MEMORANDUM

SUBJECT: Setdown Report: Zoning Commission Case No. 08-34(A) for Second-Stage Approval of a Commercial Building in the South Block (Capitol Crossing)

Exhibit 4: Proposed Plan for the South Block site, looking across 3rd Street NW.

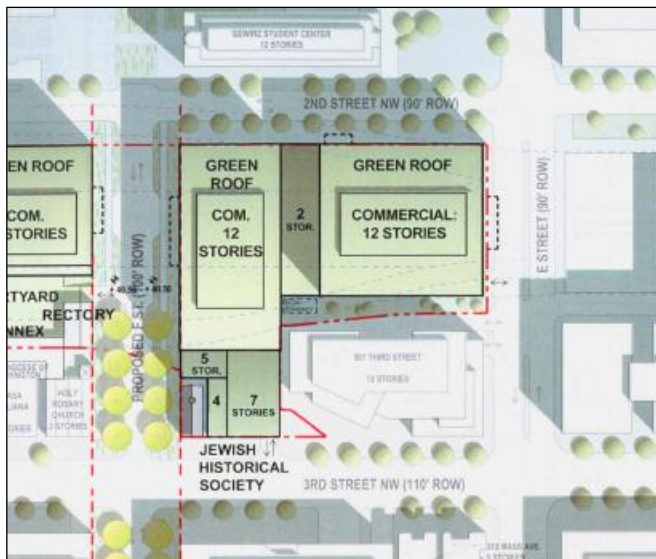
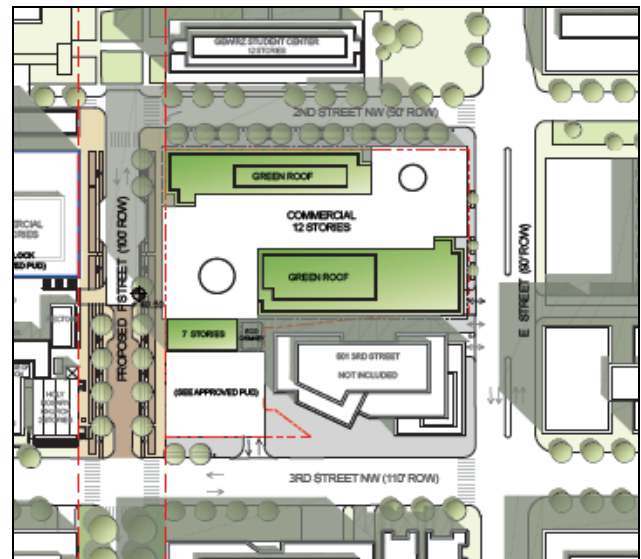
The building form would be reshaped from earlier conceptual designs approved in Order No. 08-34 (as shown in Exhibit 3 and 4 above). It now would be "organized into two parallel bars with a full-height glass atrium in the center."⁶ The massing would be concentrated along 2nd and F Streets, with a step down to seven-stories on the building's west side. Entrances on E, F, and 2nd Streets would be recessed from the main street façade to further articulate the building frontages. A consequence of the massing changes is a slight increase in lot occupancy to about 92%, which exceeds the 90% lot occupancy anticipated in previously approved drawings. The building would set back from the E Street Property line by 6'10", accommodating a width of 14' between the curb and ground floor façade.⁷ Retail spaces would line the ground floor along adjacent streets. The Applicant has indicated to OP that retail ceiling heights would be

a minimum of 12' in height. If achievable, OP encourages the Applicant to explore increasing ceiling heights to create more favored retail spaces.
